# Work Order ID 112686

Item ID: D407-667-105

Item Name: Fwd Crosstube

| Draw Nbr     | Revision Nbr |
|--------------|--------------|
| D407-667-145 | Rev C (DEO)  |

| DRAWN      | RF  | DRAWING NO.<br>D407-667-145  | REV. C<br>SHEET 1 OF 4 |

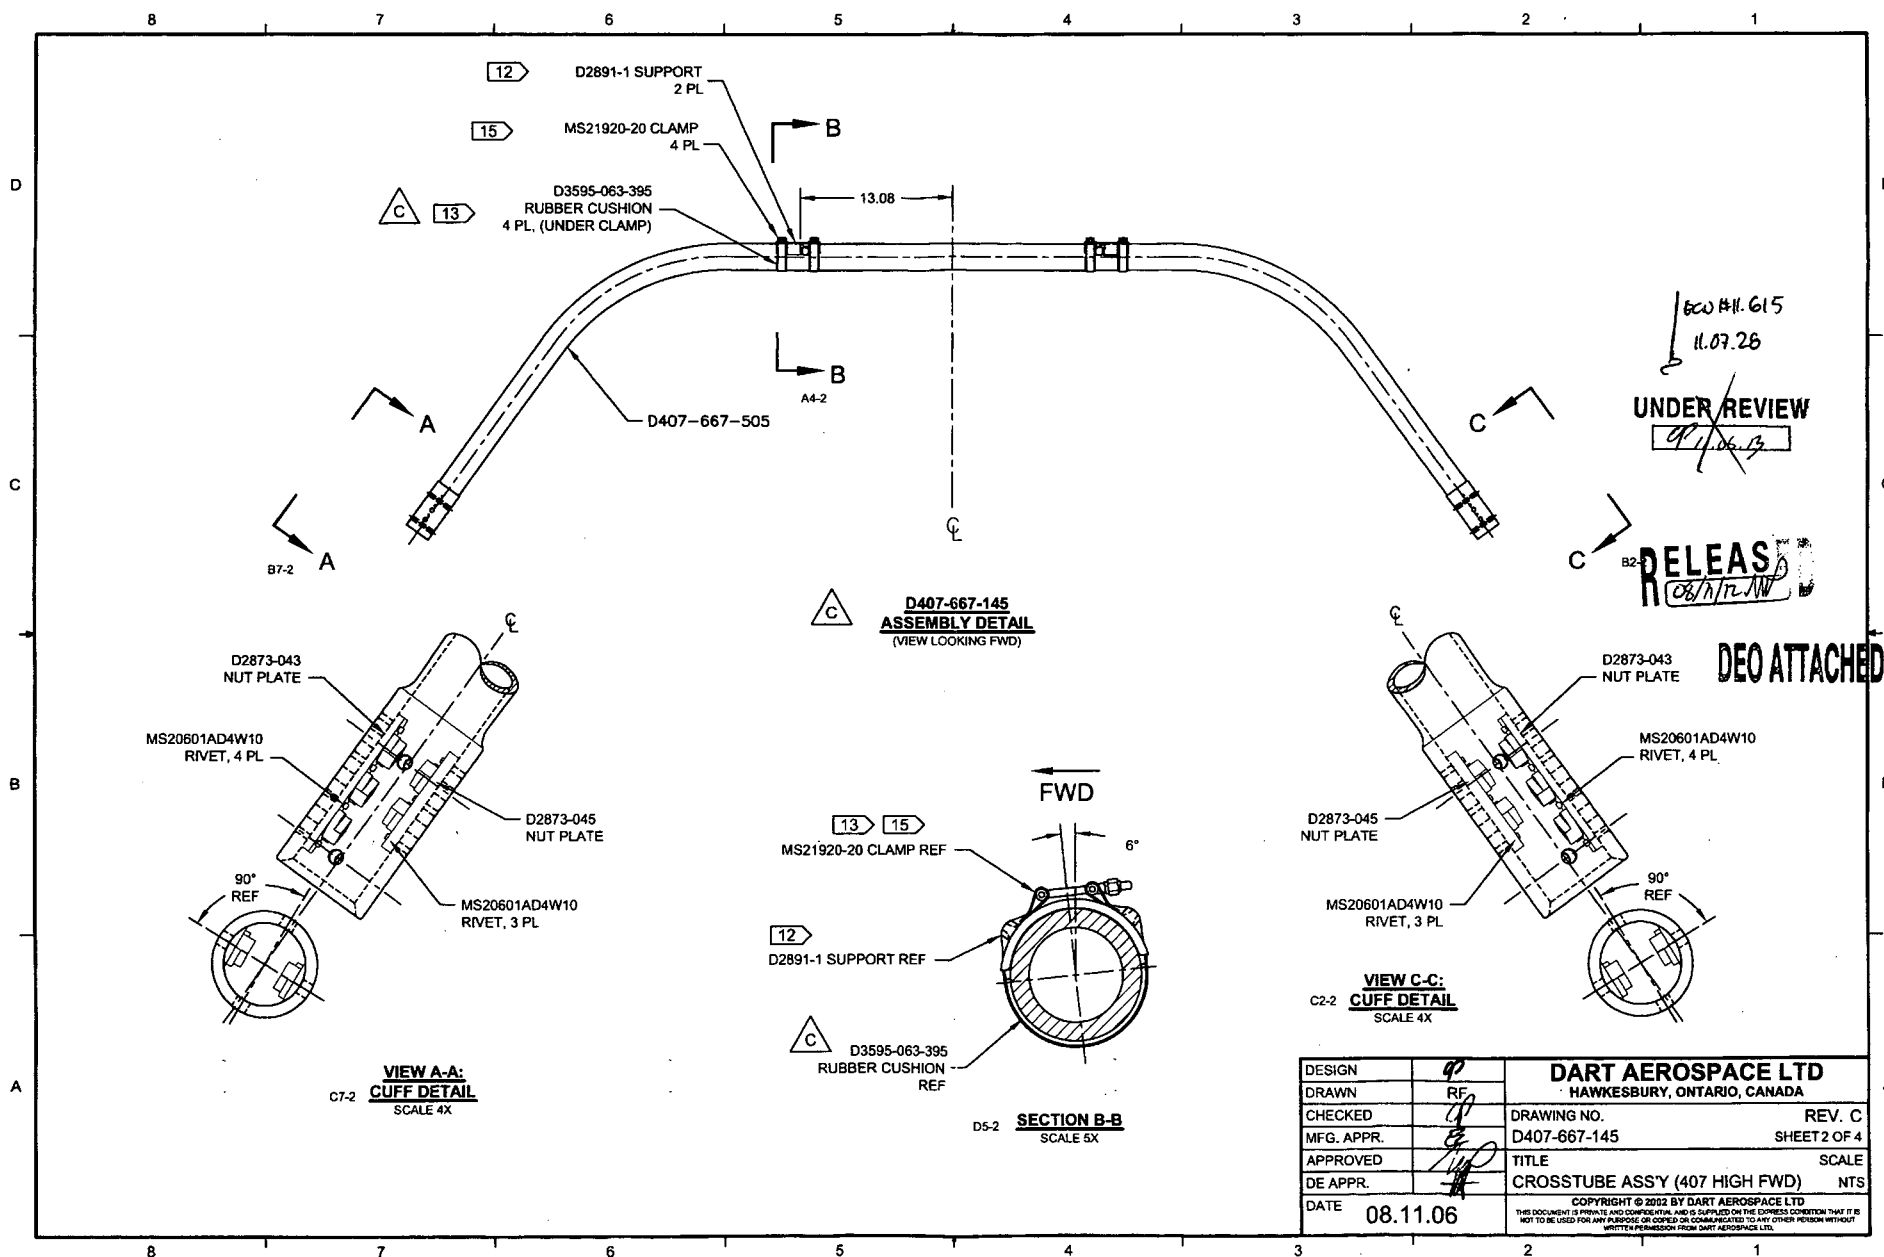
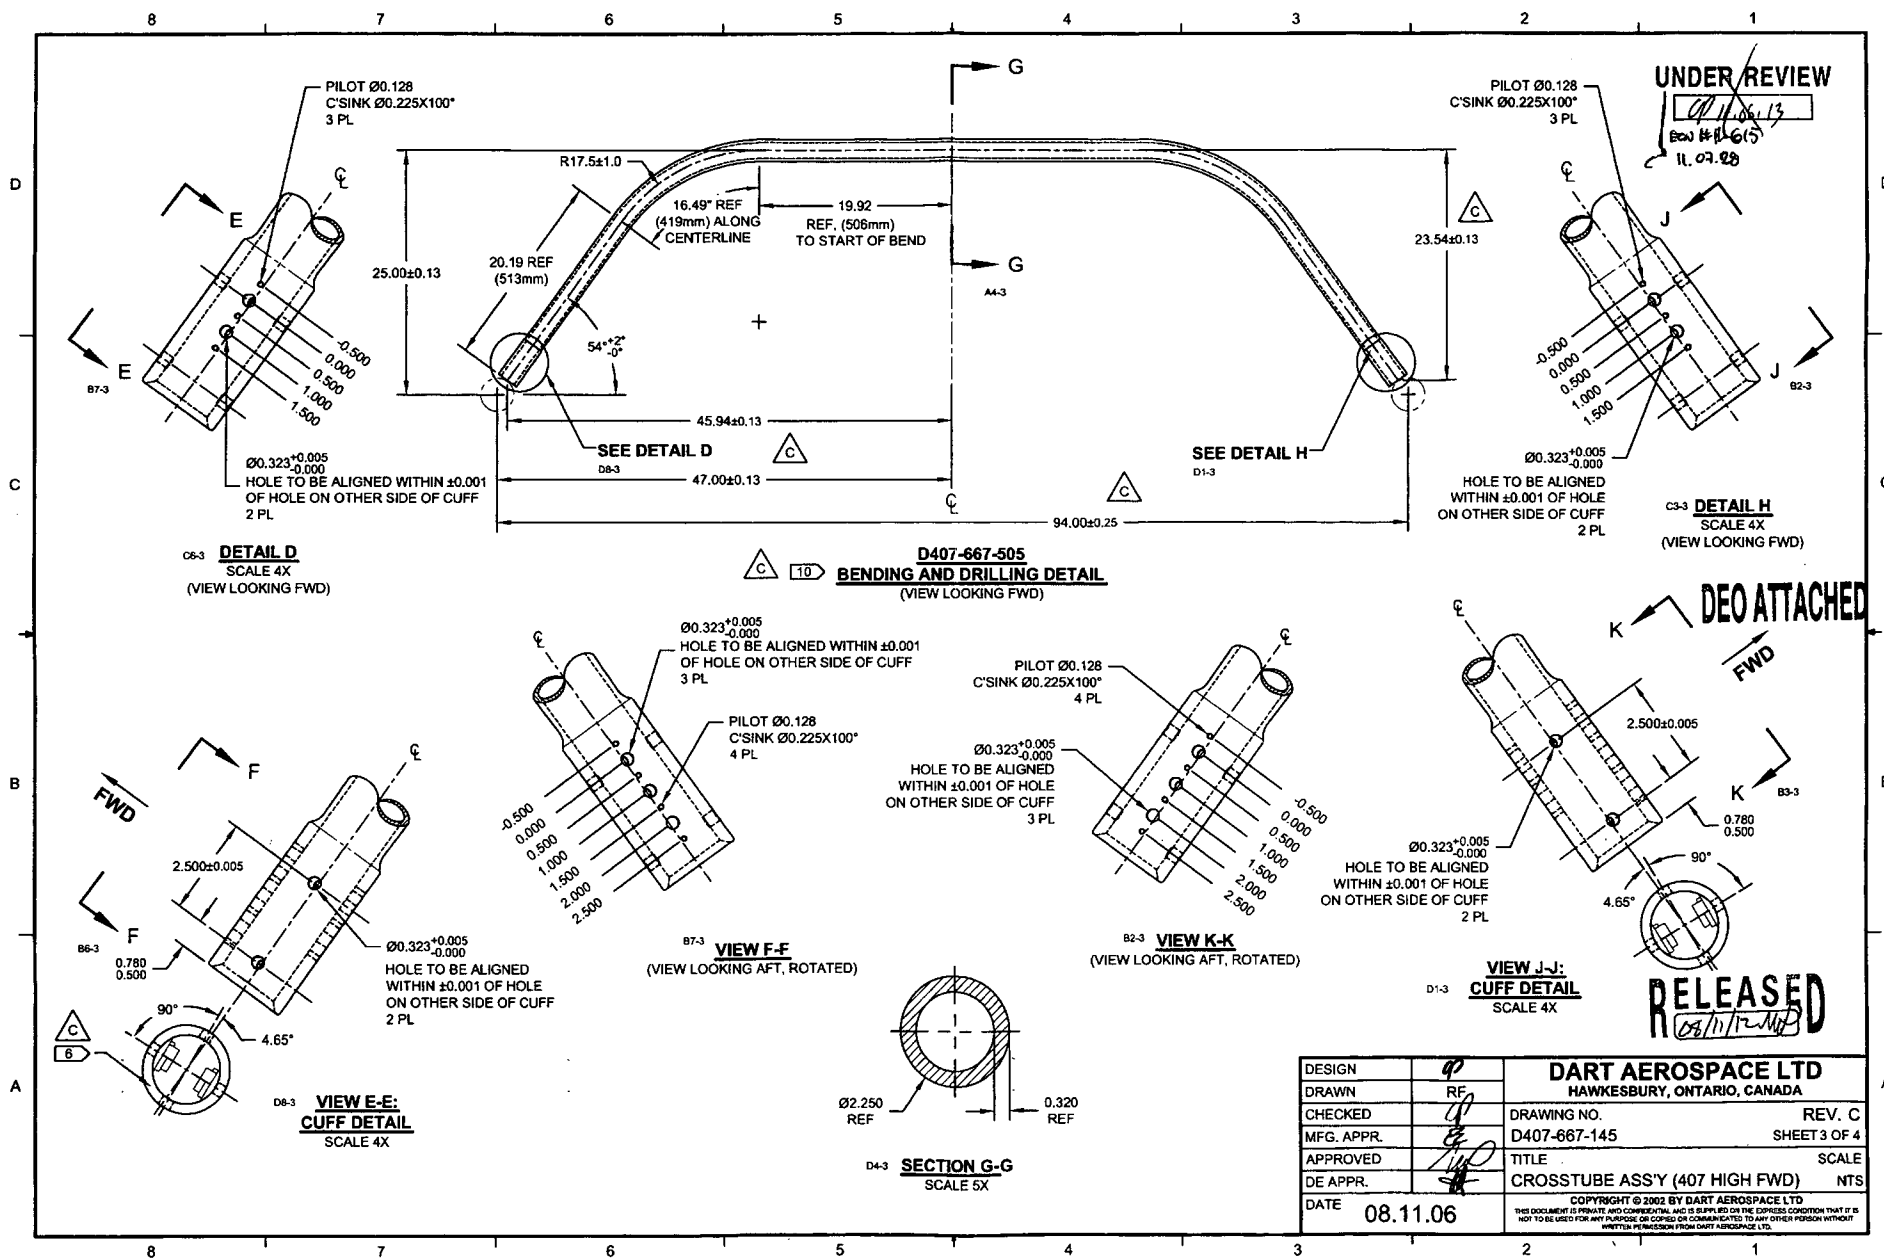
REPLACE MAGNOBOND WITH PROSEAL.

NOTE 12 & 15, SHEET 1 IS AMENDED AS FOLLOWS:

- 12) TO INSTALL D2891-1 SUPPORT: ABRAD MATING SURFACE OF SUPPORT AND CROSSTUBE WITH 180-GRIT SANDPAPER AND REMOVE RESIDUE WITH MEK (OR EQUIVALENT). APPLY A 0.04" TO 0.07" THICK LAYER OF PROSEAL 890 CLASS B-2 (OR AMS-S-8802 CLASS B-2) SEALANT TO MATING SURFACE OF SUPPORT.
- 15) TORQUE CLAMPS 80 TO 100 IN-LB. ENSURE AT LEAST 1.5 THREADS SHOWING IN SAFETY AND THAT NUT HAS NOT BOTTOMED-OUT AFTER TORQUING. **PRIOR TO PACKAGING, RE-CHECK TORQUE ON CLAMPS AFTER PROSEAL 890 SEALANT HAS CURED FOR 72 HOURS.**

**DETAIL P**  
BONDING STRAP INSTALLATION 2 PL

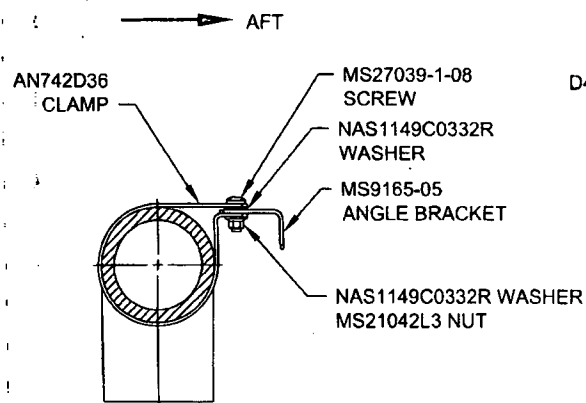
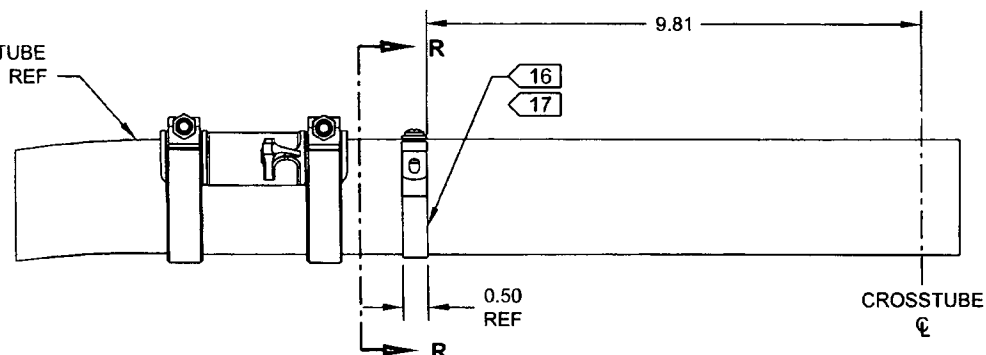
ADD ELECTRICAL GROUNDING STRAP

ADD

ADD
